LA-UR-04-6777
September 2004

Response to Concerns About Selected Regional Aquifer Wells at Los Alamos National Laboratory

Prepared by
Risk Reduction and Environmental Stewardship Division—Groundwater Protection Program

Figure 3. Geophysical logs and well screen location in the regional zone of saturation for well R-7

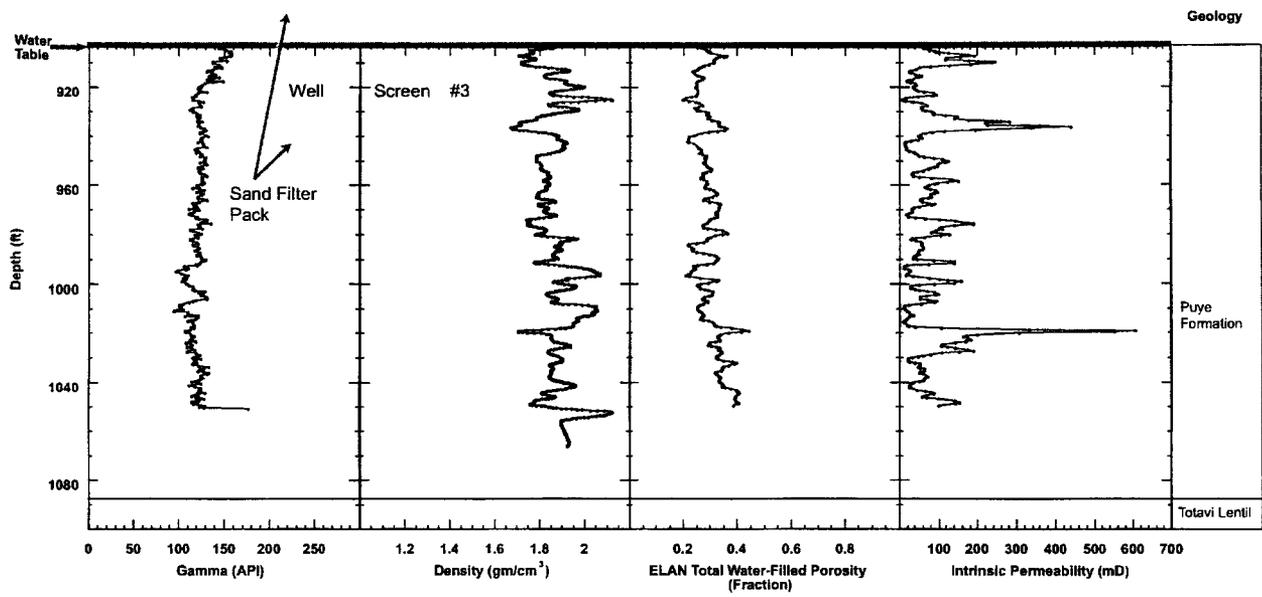
| | <p>Concerning factor b. LANL has failed to install screened intervals in the upper several hundred feet of the regional aquifer in the discrete strata that have high hydraulic conductivity. Examples of this failure are in sections of this report for wells R-7, R-15, and R-22.</p> | Question 2 |

The screens in regional aquifer wells are placed in hydrogeologic units considered important for hydrogeologic characterization and the screen lengths are appropriate for routine monitoring, if necessary. The well design team typically includes representatives from DOE, LANL, and the drilling contractor. NMED and DOE-OB review and approve the well design prior to well construction. Each of the wells cited by Mr. Gilkeson achieved the primary objective of providing information about the regional aquifer water table and all have screens located within representative hydrostratigraphic units.

Figure 4. Geophysical logs and well screen location in the regional zone of saturation for well R-15

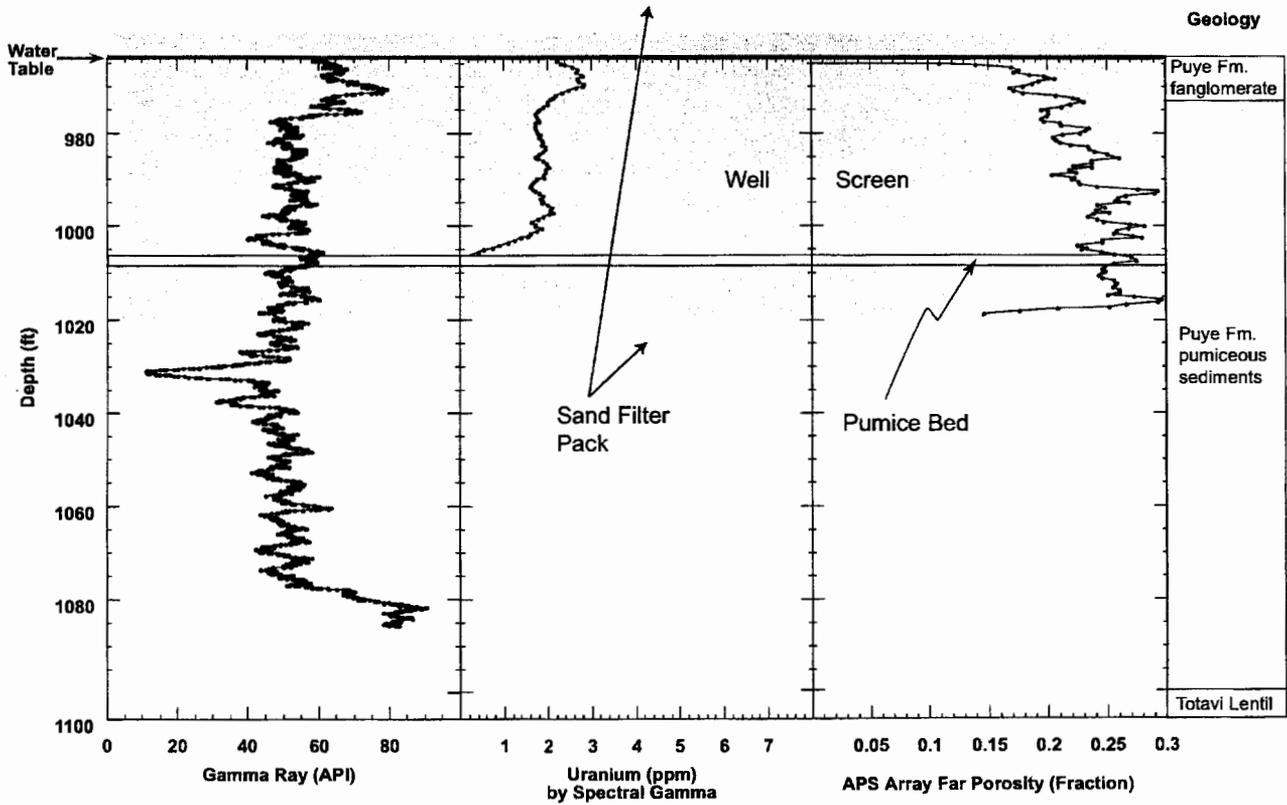
| | <p>Issues for the construction of LANL well R-15 that impact the reliability of analytical results are the use of drilling fluids in the borehole and the installation of a 60-ft long screen that straddles the top of the water table and spans intervals of aquifer strata with differing values of hydraulic conductivity. Figure 6 shows that the 60-ft screen crosses a layer of clayey fine-grained sediments that is present at a depth of 1007 to 1009 feet below land surface. Figure 6 shows the large change in static water level that has occurred since construction of the monitoring well. The installation of the long well screen across the fine-grained sediments is allowing groundwater from above the fine-grained layer to drain down inside the well and mix with groundwater present below the fine-grained layer. The mixing will dilute contaminant levels that are present at the top of the regional aquifer. LANL monitoring well R-15 does not meet RCRA requirements for representative groundwater samples.</p> | <p>Question 2</p> |

Figure 12. Concentrations of dissolved strontium (mg/L) in wells R-7, R-9, R-12, R-15, and R-22 during characterization sampling

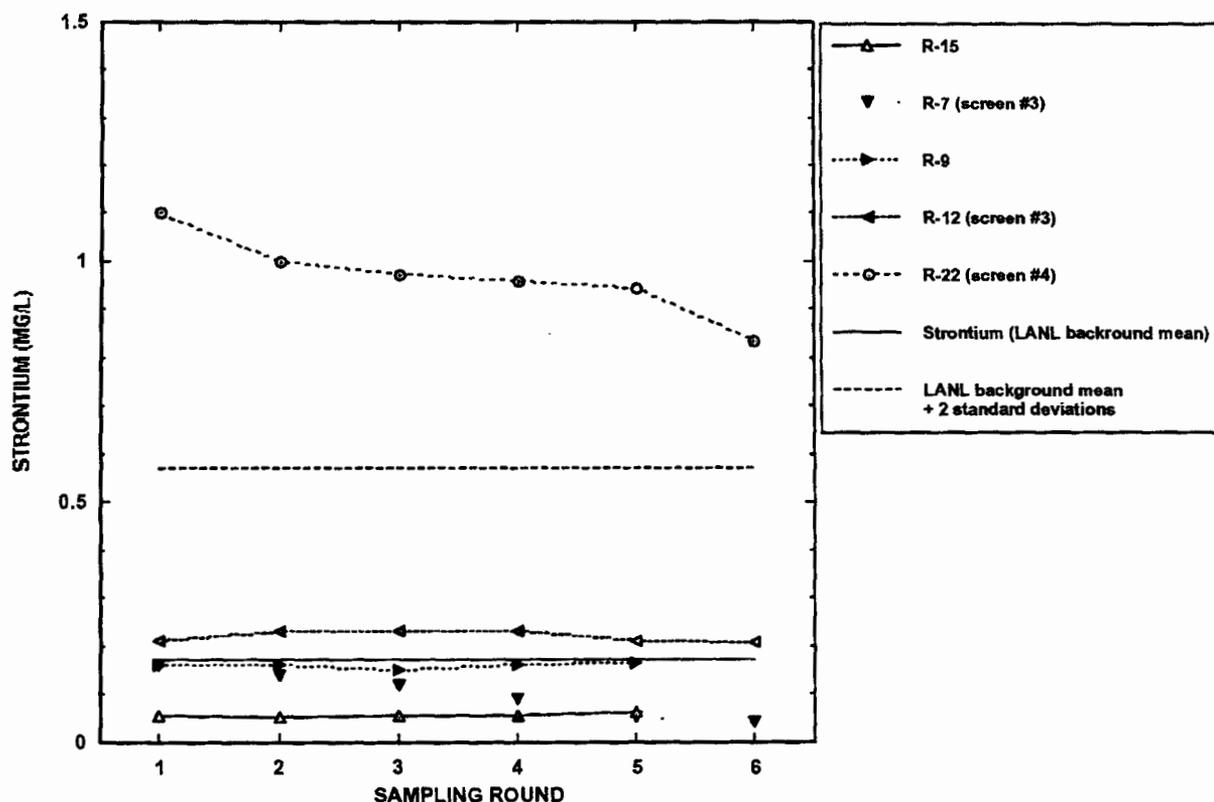
| | <p>Figure 5 shows the gradual decline in levels of strontium-90 and strontium that has occurred for screen no. 3 in well R-7 for groundwater samples collected over a one-year period because of the zone of altered chemistry that is caused by the use of drilling fluids. The unnatural chemical processes that lower the levels of strontium and strontium-90 in groundwater were introduced in the drilling fluids several months before the first groundwater samples were collected for contaminant analyses. The actual activity of strontium-90 in the regional aquifer is not known and may be much greater than the low values that are reported in the LANL geochemistry report.⁹</p> | Question 5 |
| | <p>Strontium and strontium-90 have identical chemical properties. The pronounced decline in strontium and strontium-90 levels shown in Figure 5 is because of the removal of these constituents from groundwater in the zone of unnatural chemistry that surrounds well R-7. The trend analyses presented in Figure 5 of the analytical results for well R-7 confirm that the radionuclide contaminant strontium-90 is present in the regional aquifer below Los Alamos Canyon.</p> | Question 3, Question 5 |

Figure 5 in the report by Gilkeson (2004) is a graph showing concentration of natural strontium and strontium-90 over a period from May 2001 to February 2002. Actually, the points on Mr. Gilkeson's graph represent the instrument detection limit (IDL) for strontium-90 using gas proportional counting. There is an apparent decrease during that period because the method detection limit (MDL) for this analytical method decreased as the matrix interferences diminished. Matrix interference reduces the accuracy of analytical results and comes from increased solutes in the water after drilling. These solutes are alkaline earth elements, and include magnesium, calcium, strontium and other beta-emitting isotopes that can cause interferences with strontium-90 analysis. Concentrations of natural strontium (Figure 12), magnesium, and calcium decreased during characterization sampling at well R-7 (screen 3) (Longmire and Goff, 2002). These concentration decreases are due to removal of residual drilling fluid as equilibrium conditions become re-established. The similar trend in all of these elements explains the decrease in matrix interference and accompanying lowering of the IDL for strontium-90. There has been no analytical detection of strontium-90 in regional aquifer samples from well R-7, despite the decreased IDL and concomitant increased ability to detect it.
